BEFORE THE PUBLIC UTILITY COMMISSION

LC 57

In the Matter of)
)
PACIFICORP)
dba PACIFIC POWER)
)
2013 Integrated Resource Plan)
_____)

**OPENING COMMENTS OF THE
CITIZENS' UTILITY BOARD OF OREGON**

6 *Figure 1 – Change in Average Residential Usage since 1990⁹*

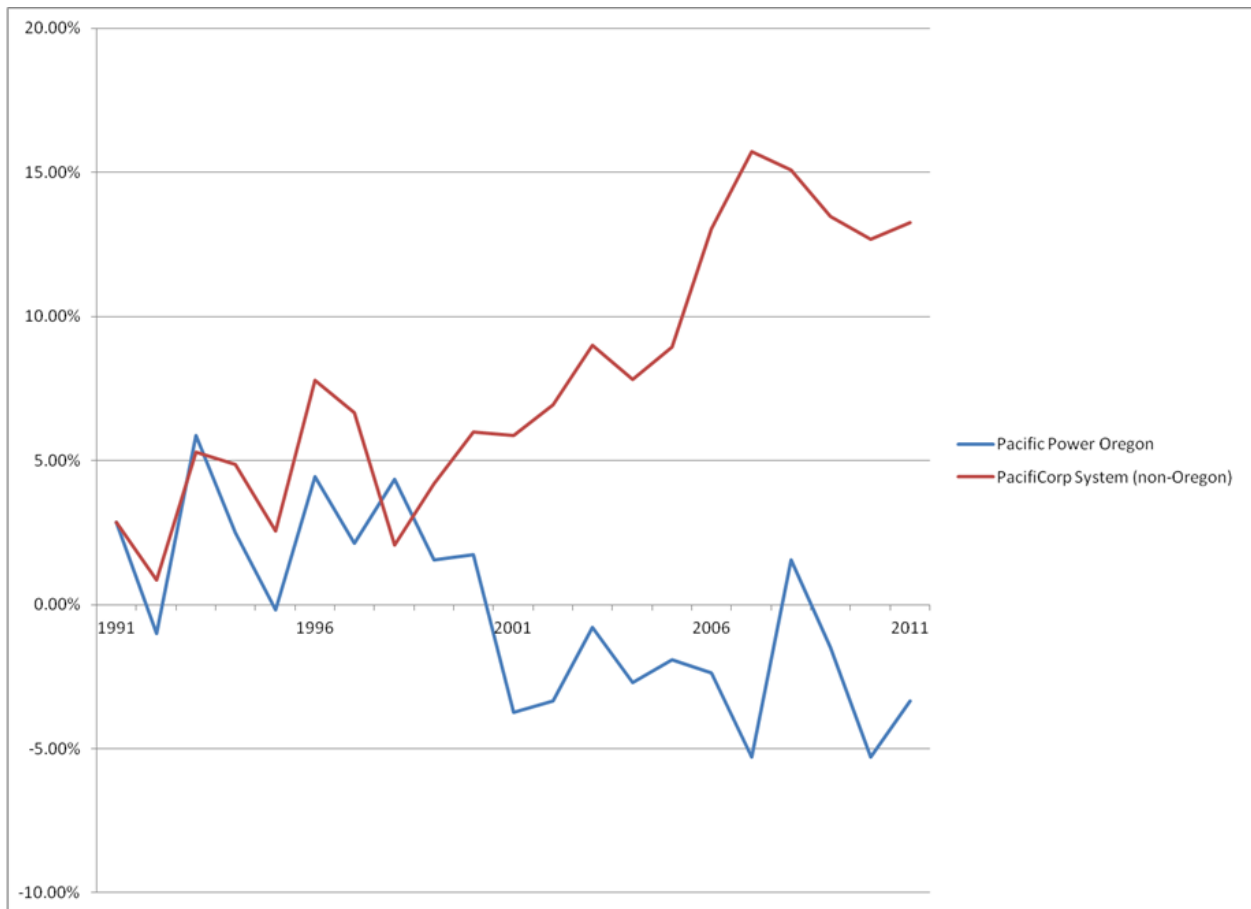
5 PacifiCorp only has to look at a diagram of Oregon’s historical energy usage to see
6 strong evidence that additional energy efficiency is achievable.³ Oregon has demonstrated a
7 decreasing trend in average residential usage over the past two decades.⁴ And, as *Table 1* reveals,
8 PacifiCorp is implementing energy efficiency at a greater rate in Oregon via the Energy Trust
9 than it is in other states using its own in-house programs. This review of Oregon’s energy
10 efficiency achievements demonstrates that the possibilities for energy efficiency in other
11 locations, including Oregon, should be more intensely investigated.

3 The amazingly positive effects of Oregon’s energy efficiency programs over time can be
4 seen by looking at the change in average residential usage since 1990. Oregon’s average
5 residential usage has declined while the combined results for other states show an increase.⁸
